OMA relaxation for high extinction ratio transmitters

John Johnson, Broadcom Inc.

100G-EPON

This contribution is in support of comments by the author against draft D1.1.

PR30 US: Cooled ONU TX

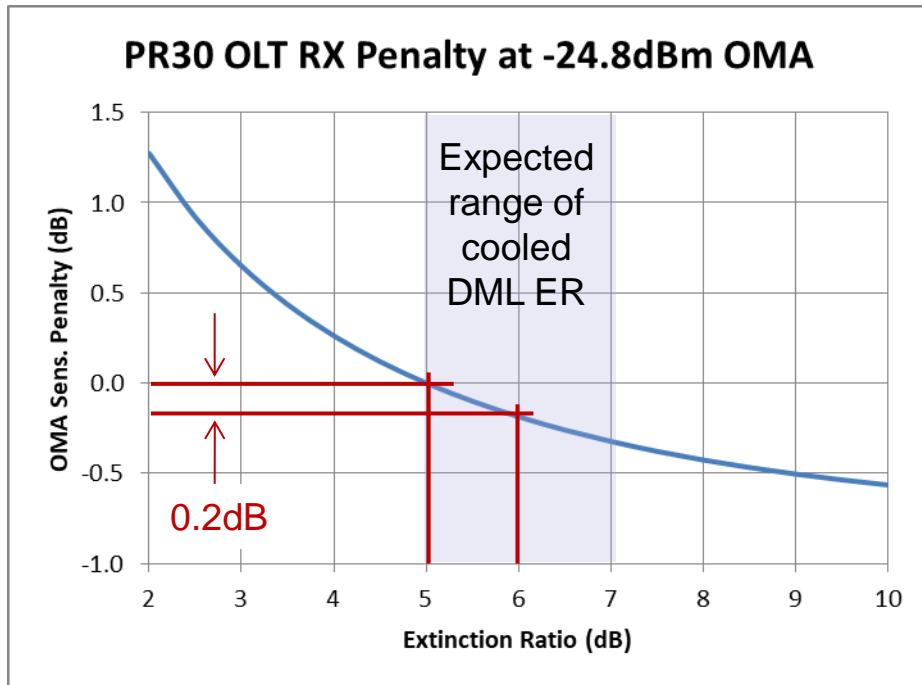
- RX OMA Sens. (min) = -24.8dBm at minimum ER = 5dB.
- ONU TX is expected to be a **cooled DML** for PR30 PMDs
- Cooled DML ER can range from 5dB (min) to ~7dB at the high end.
- ONU TX with ER ≥ 6dB need **0.2dB lower OMA** for same OLT RX sensitivity as an ONU TX with ER = 5dB.
- **Propose relaxation of 0.2dB in OMA minus TDP (min) for PR30 ONU TX with ER ≥ 6dB.**

Description	Value	Unit
Launch power in OMA minus TDP, each lane (min):		
for extinction ratio ≥ 6 dB	4	dBm
for extinction ratio < 6 dB	4.2

PR20 US: Uncooled ONU TX

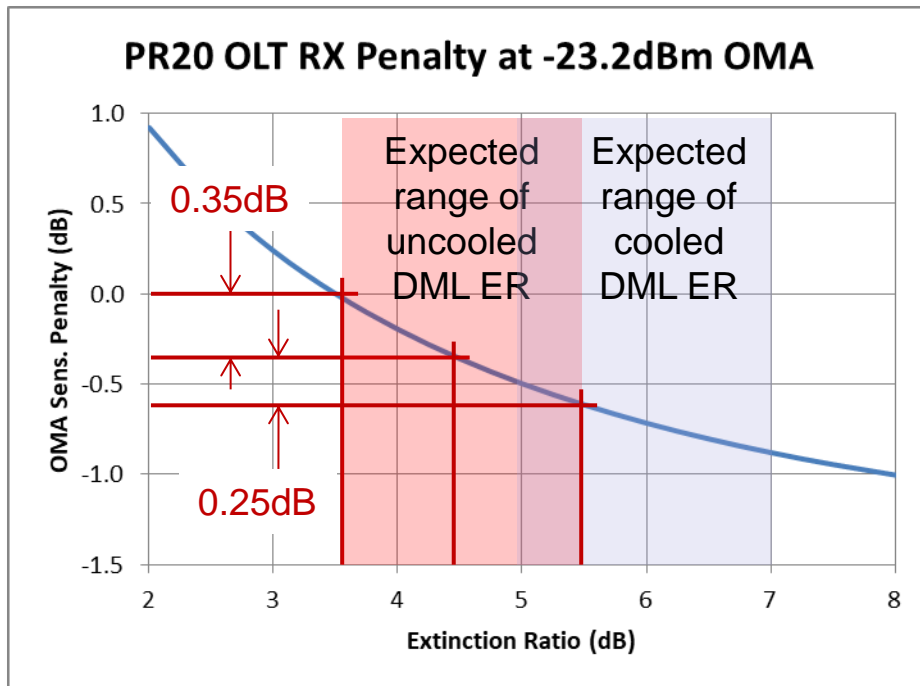
- RX OMA Sens. (min) = -23.2dBm at minimum ER = 3.5dB.
- ONU TX is expected to be an **uncooled DML** for PR20 25G PMDs, but 50/50G ONUs may use **cooled DMLs** to overcome mux losses.
- Uncooled DML ER can range from 3.5dB (min) to ~5.5dB at the high end. Cooled DML ER can be up to ~7dB.
- ONU TX with ER > 4.5dB need **0.35dB lower OMA** for same OLT RX sensitivity as an ONU TX with ER = 3.5dB. (Cooled) ONU TX with ER > 5.5dB need 0.6dB lower OMA.
- **Propose relaxation of 0.3dB in OMA minus TDP (min) for PR20 ONU TX with ER ≥ 4.5 dB, and 0.6dB relaxation for ER ≥ 5.5 dB.**

Description	Value	Unit
Launch power in OMA minus TDP, each lane (min):		
for extinction ratio ≥ 5.5 dB	0.2	
for extinction ratio ≥ 4.5 dB	0.5	dBm
for extinction ratio < 4.5 dB	0.8

PR30 DS: Cooled EML TX

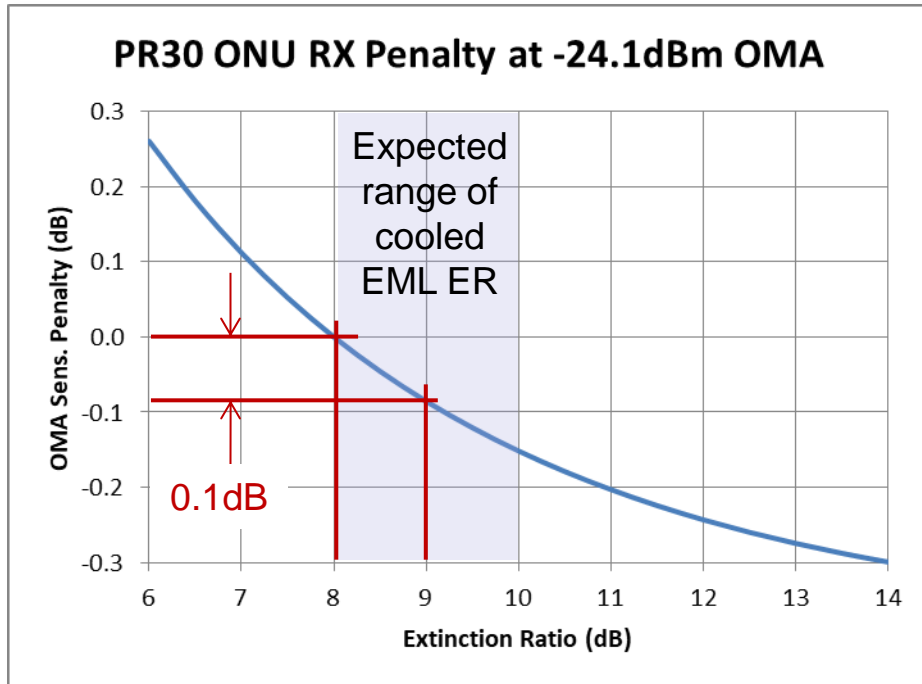
- RX OMA Sens. (min) = -24.1dBm at minimum ER = 8dB.
- OLT TX is expected to be a **cooled EML**.
- Cooled EML ER can range from 8dB (min) to ~10dB at the high end.
- OLT TX with ER > 9dB need **0.1dB lower OMA** for same ONU RX sensitivity as an OLT TX with ER = 8dB.
- **Propose relaxation of 0.1dB in OMA minus TDP (min) for PR30 OLT TX with ER ≥ 9dB.**

Description	Value	Unit
Launch power in OMA minus TDP, each lane (min):		
for extinction ratio ≥ 9 dB	4.8	dBm
for extinction ratio < 9 dB	4.9

PR20 DS: Cooled EML TX

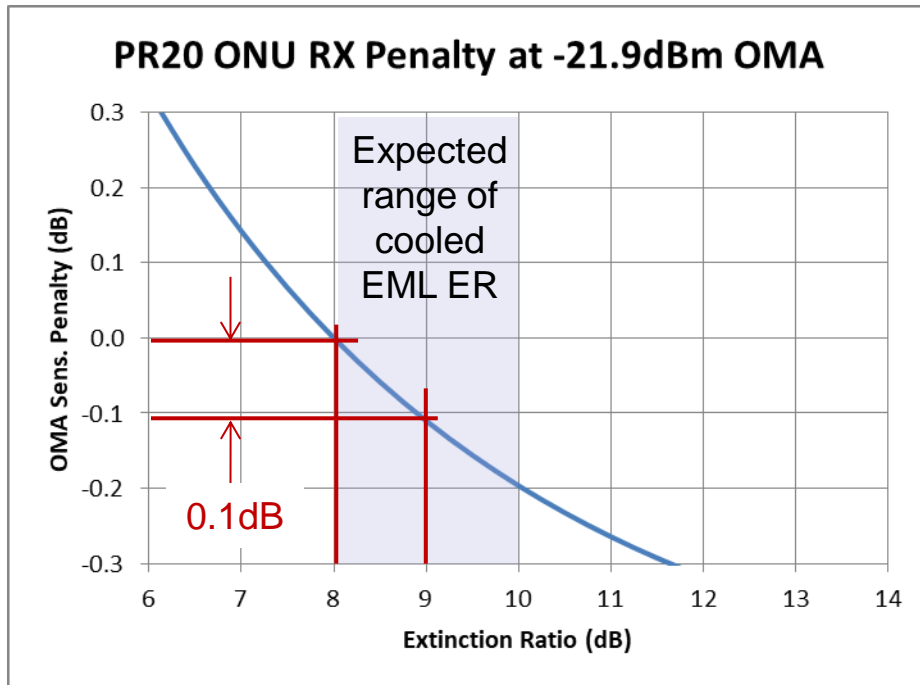
- RX OMA Sens. (min) = -21.9dBm at minimum ER = 8dB.
- OLT TX is expected to be a **cooled EML**.
- Cooled EML ER can range from 8dB (min) to ~10dB at the high end.
- OLT TX with ER > 9dB need **0.1dB lower OMA** for same ONU RX sensitivity as an OLT TX with ER = 8dB.
- **Propose relaxation of 0.1dB in OMA minus TDP (min) for PR20 OLT TX with ER ≥ 9dB.**

Description	Value	Unit
Launch power in OMA minus TDP, each lane (min):		
for extinction ratio ≥ 9 dB	2	dBm
for extinction ratio < 9 dB	2.1
